Department of Transportation

July 21, 2023

Subject: Staff Comments on North Stoughton Rd Design Alternatives, version 3.

Concept 1

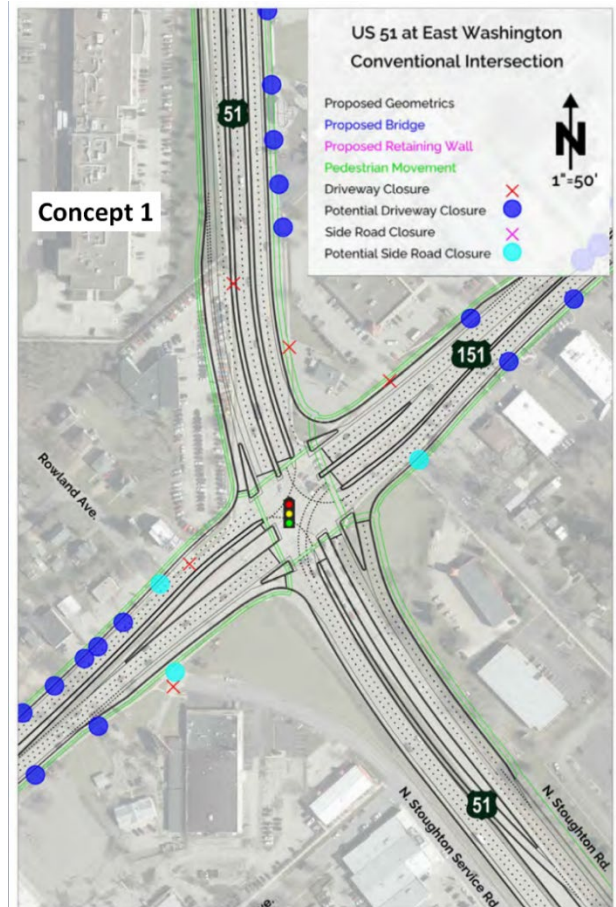
The existing Stoughton Rd and East Washington Ave intersection is poor with long crossing distances for pedestrians and bicycles. The proposed concept is similar to what exists with similar numbers of lanes. While poor, Concept 1's at-grade crossing is perhaps better and more urban than many of the concepts that have been presented.

This concept has relatively straight forward pedestrian and bicycle paths. Crossing distances are slightly longer due to increased island size. With the high volumes on both East Washington Ave and Stoughton Rd, it is important that pedestrians are able to cross each approach in a single phase, without having to use an island as a refuge. We encourage WisDOT to reconsider the need for the SBRT and EBRT slip lanes at East Washington & Stoughton Road. These slip lanes add complexity and delay to the pedestrian crossing.

We also encourage WisDOT to maintain some type of access between the North Stoughton Service Road and East Washington Ave.

The concept has up to three potential side road closures due to policy reasons. Because this access loss is policy rather than a geometric necessity, and these side road access have existed for decades as right-in/right-out driveways, staff recommend that these accesses be preserved.

these access points would result in numerous relocations and require that land remain vacant for lack of access. As with street access, staff recommend that these accesses be preserved as right-in/right-out.

As mentioned, if potential access closures occur it would result in numerous relocations. Staff recommend these accesses be preserved. This would allow both preservation of uses and future redevelopment in most quadrants of the intersection.

Concept 2

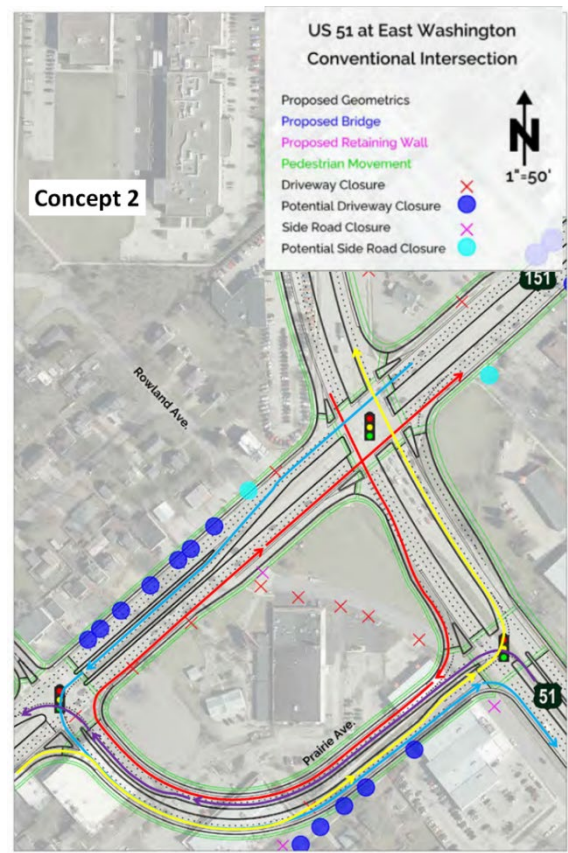
This concept, while adding one intersection to East Washington, reduces the size of the Stoughton Road/East Washington Ave intersection and keeps all movements at one level.

This concept has relatively straightforward pedestrian and bicycle paths. Crossing distances could be shorter due to reduced number of lanes that need to be crossed. We would encourage WisDOT to narrow the very large median islands that increase crossing distances and clearance times. While another intersection is added, the signal timing for both intersections would be more straightforward with fewer turning phases. As mentioned previously, with the high volumes on both East Washington Ave and Stoughton Rd, it is important that pedestrians are able to cross each approach in a single phase, without having to use an island as a refuge.

The concept has up to two potential side road closures due to policy reasons, and a realignment of the North Stoughton Rd Service Road. Because this access loss is policy rather than a geometric necessity, and these side road access have existed for decades as right-in/right-out driveways, staff recommend that these accesses be preserved. Staff also recommend access be allow on Prairie Ave, so that parcel would be available for redevelopment.

This concept has numerous potential access removals, again for policy reasons rather than geometric. As with the previous alternative, staff recommend that these accesses be preserved as right-in/right-out as they have currently existed for decades. It is important for access to be preserved on Prairie Ave so that land parcels on both sides are able to host active land uses.

As mentioned, if potential access closures occur it would result in numerous relocations. Staff recommend these accesses be preserved as right-in/right-out. It is likely portions of the shopping mall in the southwest quadrant could be relocated. It is important that this parcel maintain active uses through the preservation of some type of access. Because this intersection type does not have grade differentials that mandate access closure, there may be more opportunity for active land uses adjacent to the corridor.

Concept 3

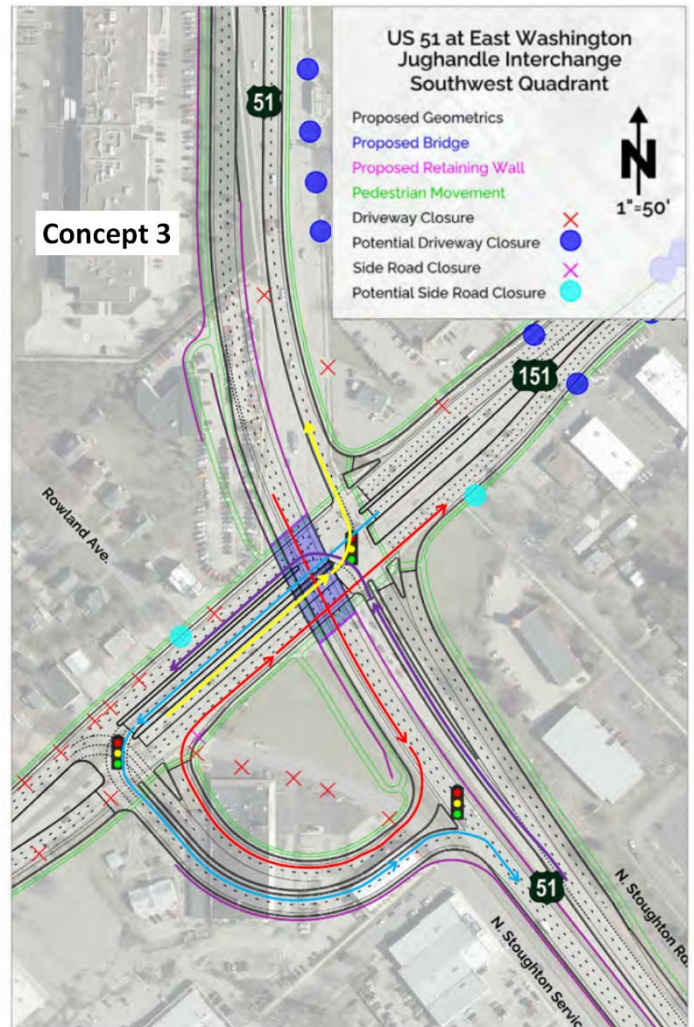
While grade separating one movement, this jughandle still incorporates signals in the northbound, southbound, eastbound and westbound directions. It adds intersection capacity without introducing a freeway interchange. This helps preserve urban speeds, and probably would not encourage speeding between up and downstream signalized intersections.

This concept reduces the number of lanes a pedestrian has to cross in the east-west direction by half, and eliminates many of the conflicting left turns from the signal timing. East-West pedestrian and bicycle routing is straightforward and direct. Extra efforts

are needed to provide pedestrian/bicycle connectivity in the north-south direction on the west side of the intersection. This includes, but is not limited to a signalized crossing on the west side of the jug handle intersection with East Washington. This was accomplished at Junction Rd/Mineral Point Rd through a spiraled path grade separation. The City of Madison recommends improving bike connectivity from neighborhoods south of East Washington to destinations and the Madison bike network north of East Washington.

The concept has up to two potential side road closures due to policy reasons. Again, staff recommends maintaining these sideroad access points as right-in/right-out.

This concept has numerous confirmed access removals. Some of these access removals are necessary due to grade changes, and the southwest quadrant ramp construction. Madison requests WisDOT re-evaluate the listed access removals in the westbound East Washington direction to see if all are necessary. These confirmed access removals would create a strip of relocations, and the ensuing vacant undevelopable land, that is not beneficial.

The access closures in the northeast quadrant would relocate Walgreens, an important area business. Since the grade separated lanes are in the southbound direction, there should be no additional grade challenges with providing access to Walgreens. Measures should be taken to preserve this access and business. Similarly, westbound East Washington Ave would have all accesses removed – resulting in a strip of relocations and corresponding vacant undevelopable land. Yet, there appears to be no great profile differential on East Washington Ave that would mandate these access closures. Staff recommend these accesses be preserved as right-in right-out to the extent possible. The southwest quadrant would be relocated, and there are no alternatives to this relocation. Yet, with the preservation of access, the northeast and southeast quadrants could remain active land uses. The southbound horizontal curve is designed so that it could relocate 3571 Stoughton Road. This building should be preserved.

Concept 4

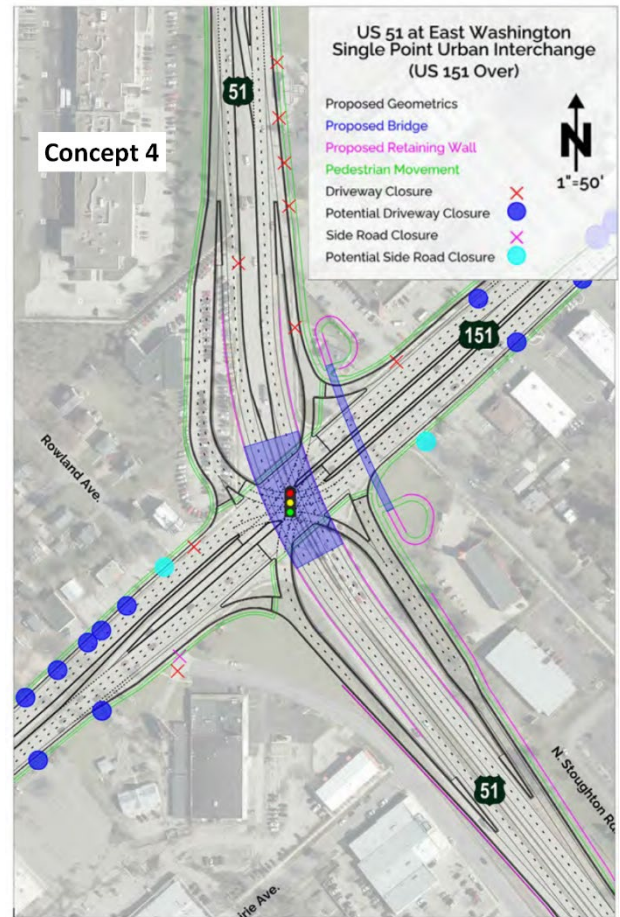
This concept is one of the more impactful concepts. It constructs a freeway interchange between two signalized intersections, which will likely create speeding problems in the urban street section to the north. Examples of where isolated interchanges pose similar challenges exist at Aberg and the at-grade intersections north of this interchange.

This concept technically reduces the number of lanes a pedestrian has to cross in the east-west direction, but there are multiple islands a pedestrian would have to travel through. Single Point Interchanges are very poor for crossings in the grade separated direction because there are no traffic gaps in the turning or through movements. Consequently, this movement must be handled through a grade separated pedestrian crossing. At the Verona Road Interchange, this is handled with a tunnel on the south approach. At the US 51/East Washington interchange, pedestrian crossing would be accommodated on the east approach through a spiraled ramp. No accommodations would be provided on the west approach. There is concern that some pedestrians would cross at-grade in the north-south direction to avoid the indirection of the pedestrian bridge on the east approach, and the total lack of north-south pedestrian accommodations on the west approach. Madison has had poor compliance/usage of the pedestrian bridge similar to this proposal crossing East Washington Ave at Marquette

Pedestrian crossings in the East – West direction would be broken into 4 separate crossings which would add substantial signal delay to the pedestrian crossing. Vulnerable users, such as the visually challenged or young bike riders, would have difficulty traveling through the interchange. The pedestrian crossings of some slip lanes shown may pose a hazard as people crossing on foot often disobey pedestrian signals when the crossing distance is short and delay high.

The concept has up to two potential side road closures due to policy reasons. Again, staff recommends maintaining these sideroad access points as right-in/right-out.

This concept has numerous confirmed access removals. Some of these access removals are necessary due to grade changes associated with the ramps. It is likely most entities in the northeast quadrant (Walgreens) would need relocation. Additionally, most businesses on the east side of Stoughton Rd and north of East Washington would lose access and be relocations.

For East Washington, Madison requests WisDOT evaluate the potential access removals in the westbound East Washington direction to see if all are necessary. If realized, these access removals would create a strip of relocations, and the ensuing vacant undevelopable land, that is not beneficial.

Unavoidable access closures in the northeast quadrant would relocate Walgreens, an important area business, and businesses north of Walgreens. Similarly, westbound East Washington Ave would likely have accesses removed because of their proximity to a freeway ramp terminal. This would result in a strip of relocations and corresponding vacant undevelopable land. Staff recommend these accesses be preserved as right-in right-out to the extent possible.

Note: If WisDOT feels that some type of interchange alternative must be brought forward, an alternative to the Single Point Urban Interchange could be a tight diamond interchange with north-south being the dominant direction. Staff had previously provided negative comments to WisDOT regarding a tight diamond, but a tight diamond decreases complexity with pedestrian and bicycle routing.

Concept 5

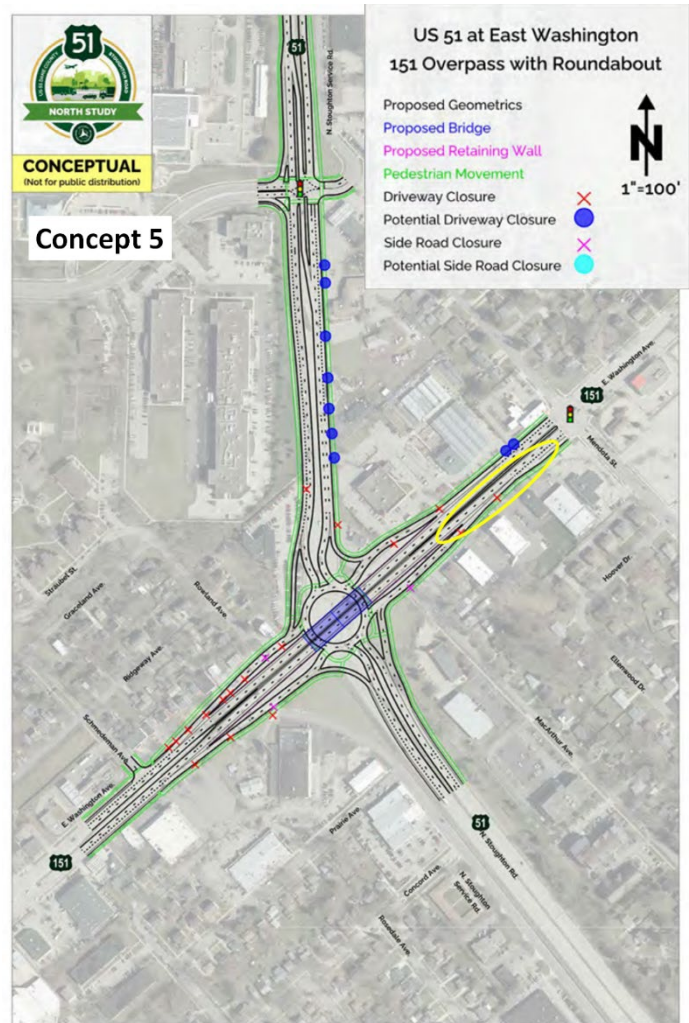
This concept is also one of the more impactful concepts. It constructs a somewhat unconventional interchange with the east-west direction being the dominant direction. The interchange is placed between two signalized intersections on East Washington Ave. This introduces a freeway treatment between two urban intersections. This could encourage speeding between signals on East Washington.

Concept 5 has pedestrians and cyclists cross the intersection at the depressed roundabout level. Pedestrian crossings at roundabouts tend to be indirect, and the roundabout bypass lanes in the intersection accentuate this challenge. North-south crossings would have fewer vehicles and more traffic gaps to cross. East-west pedestrians would have to cross larger traffic volumes without the aid of a traffic signal. Bicycle traffic would have very indirect routing through the interchange unless they chose to take a lane. Because of the bypass lanes, a cyclist would likely need to stop and wait 4 times to travel east-west through the roundabout.

Madison requests WisDOT reconsider the need for slip lanes for the EBRT, SBRT, and WBRT directions. Some may be needed for truck turning radii, but the extent that they can be reduced or eliminated would reduce speeds.

The concept has three confirmed and unavoidable access street closures

This concept has numerous confirmed access removals. Some of these access removals are necessary due to grade changes associated with the ramps. It is likely most entities in the northeast quadrant (Walgreens) would need relocation. Additionally, most properties west of Stoughton Rd and north of East Washington would lose access and be relocations.

For East Washington, Madison requests WisDOT evaluate the potential access removals in the westbound East Washington direction to see if all are necessary. If realized, these access removals would create a strip of relocations, and the ensuing vacant undevelopable land, that is not beneficial.

Unavoidable access closures in the northeast quadrant would relocate Walgreens, an important area business, and businesses north of Walgreens. Similarly, westbound East Washington Ave would likely have accesses removed because of their proximity to a freeway ramp terminal. This would result in a strip of relocations and corresponding vacant undevelopable land. Staff recommend these accesses be preserved as right-in right-out to the extent possible.

Concept 7

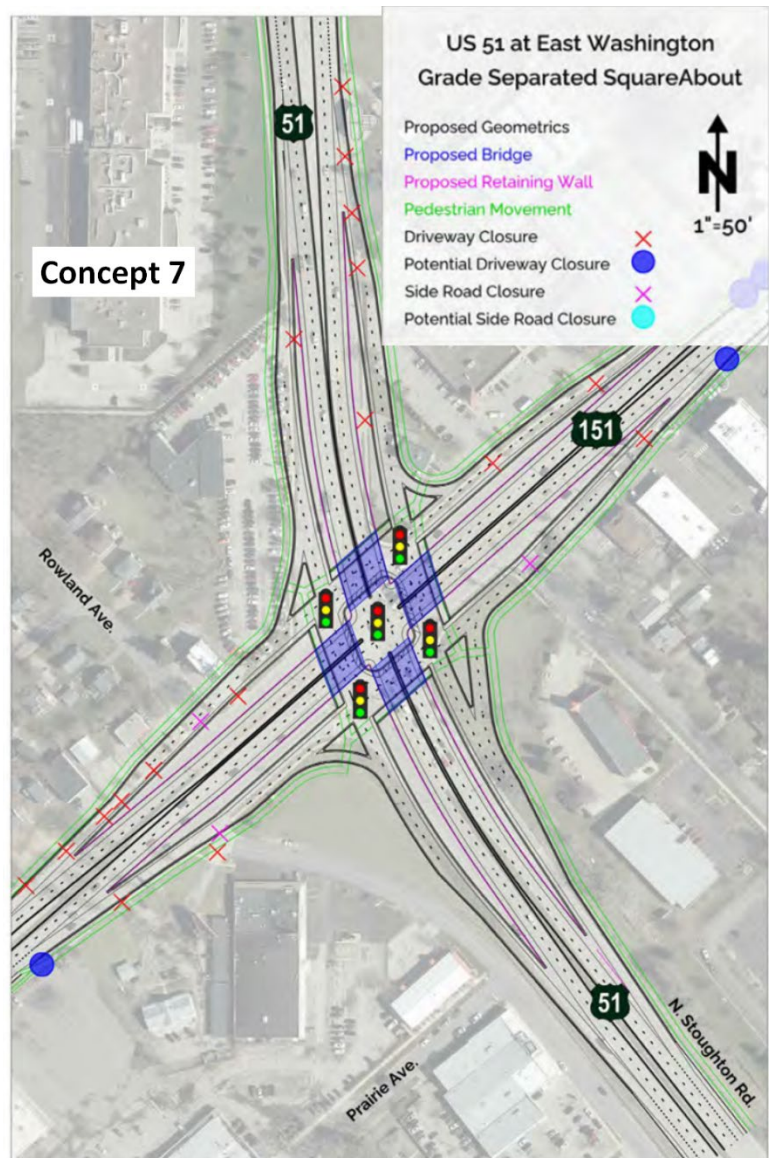
The benefits and impacts of this concept are very similar to Concept 6, except the signalized intersections for turning movements would provide simpler and more direct routes for pedestrians and bicycles. As mentioned with Concept 6, the signalized intersection for through movements could be unexpected for what appears to be an interchange and lead to more crashes.

This concept is also one of the more impactful concepts. It constructs a grade separated intersection between two signalized intersections on East Washington Ave. As mentioned, the signal for through movements would be unexpected, yet would be consistent with up and down stream signals on both East Washington and Stoughton Road.

Concept 7 has pedestrians and cyclists cross the intersection at the raised mini couplet level. The crossings are direct and straight forward, and the short-cycle signal timing would not create a lot of delay. Generally pedestrian crossing with this concept are better than those for Concept 6.

Because all through movements are removed and depressed, crossing travel volumes for pedestrians and cyclists are much more manageable.

The concept has three confirmed and unavoidable access street closures. Some type of connection (not shown) would be needed for the Stoughton Rd frontage road.

This concept has numerous confirmed access removals. Many of these access removals are necessary due to grade changes associated with the ramps. It is likely most entities in the northeast quadrant (Walgreens) and northwest quadrant (residences) would need relocation. Additionally, most businesses on the east side of Stoughton Rd and north of East Washington would lose access and be relocations.

If realized, these access removals would create a strip of relocations, and the ensuing vacant undevelopable land, that is not beneficial.

Unavoidable access closures in the northeast quadrant would relocate Walgreens and businesses north of Walgreens. Similarly, westbound East Washington Ave would likely have accesses removed because of their proximity to a freeway ramp terminal. This would result in a strip of relocations and corresponding vacant undevelopable land. Staff recommend these accesses be preserved as right-in right-out to the extent possible. Grade changes and ramps would prevent access in almost all quadrants, relocating many businesses and preventing new development.

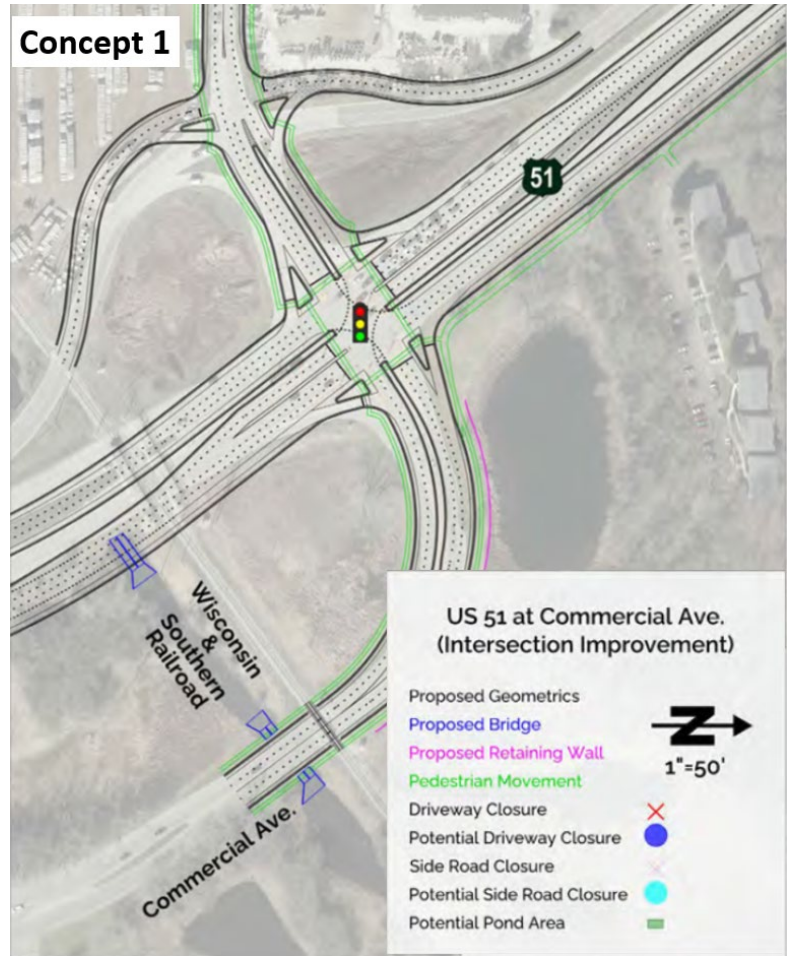
The realignment of the North Stoughton Service road provides very modest throat distance improvements for the impacts generated. Staff recommend revising this portion of the alternative.

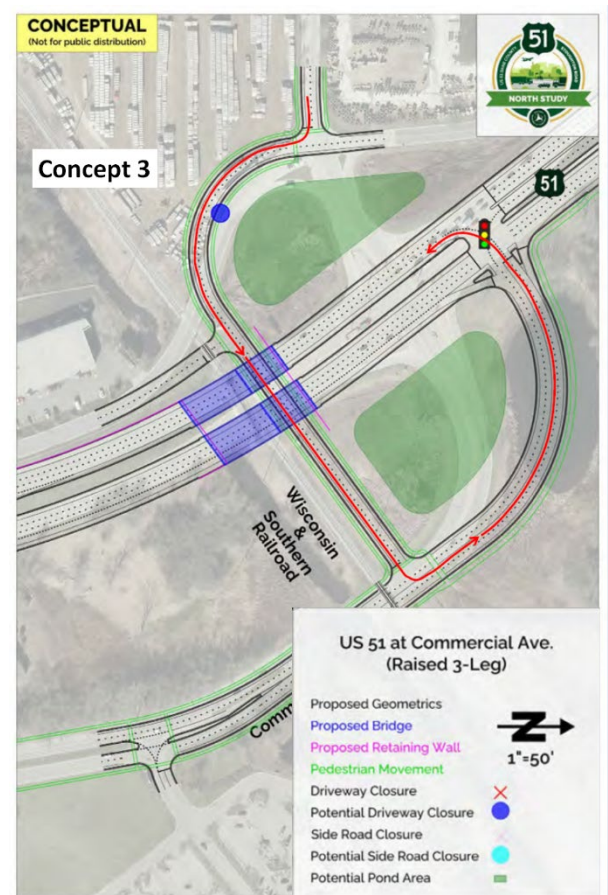
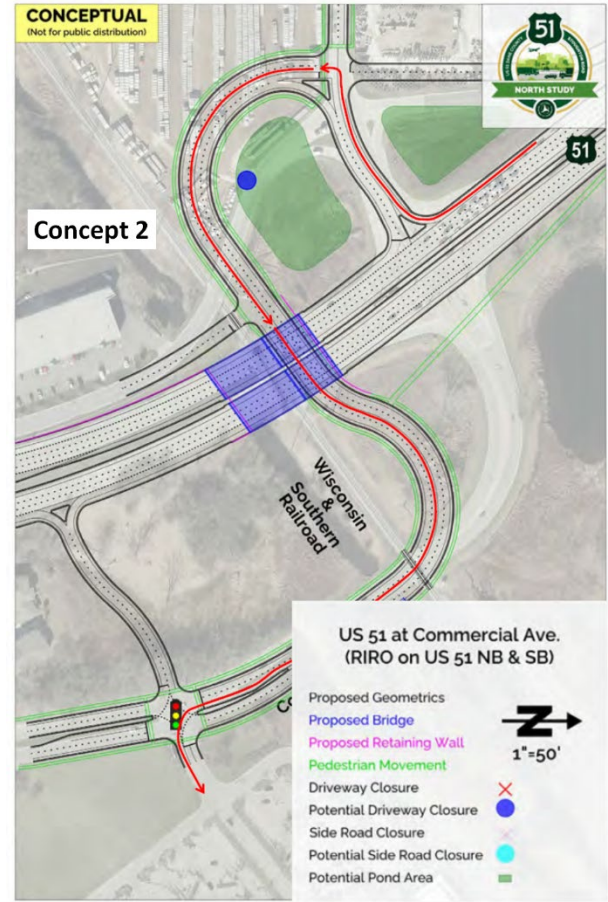
Concepts 2 and 3 both provide a grade separated WSOR crossing, and therefore could provide benefits if passenger rail is brought to the Madison area. These alternatives also provide a less stressful crossing for pedestrians and cyclists. Staff have no strong preference between concepts.

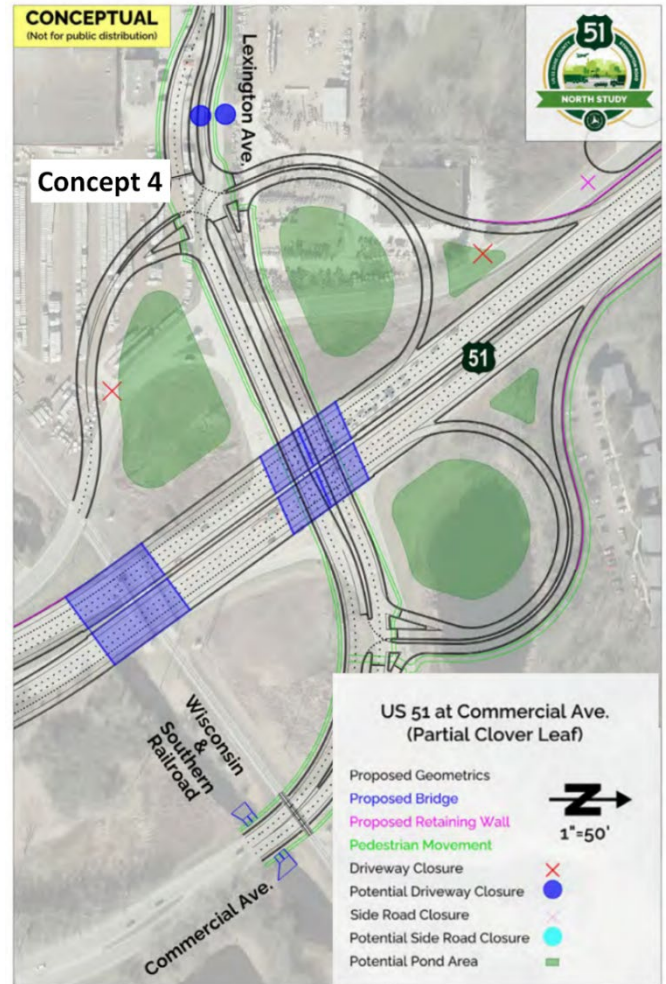
Concept 4 places a freeflowing interchange ramps just 0.3 miles from the signalized Highway 30 ramp terminals, and 0.4 miles the signalized East Washington Ave intersection. The freeflowing ramps are contrary to the intersection control both up and down stream and could lead to higher speeds and more severe crashes. Concept 4 also requires two bridges and has greater right of way impacts. Therefore Concept 4 is not recommended.
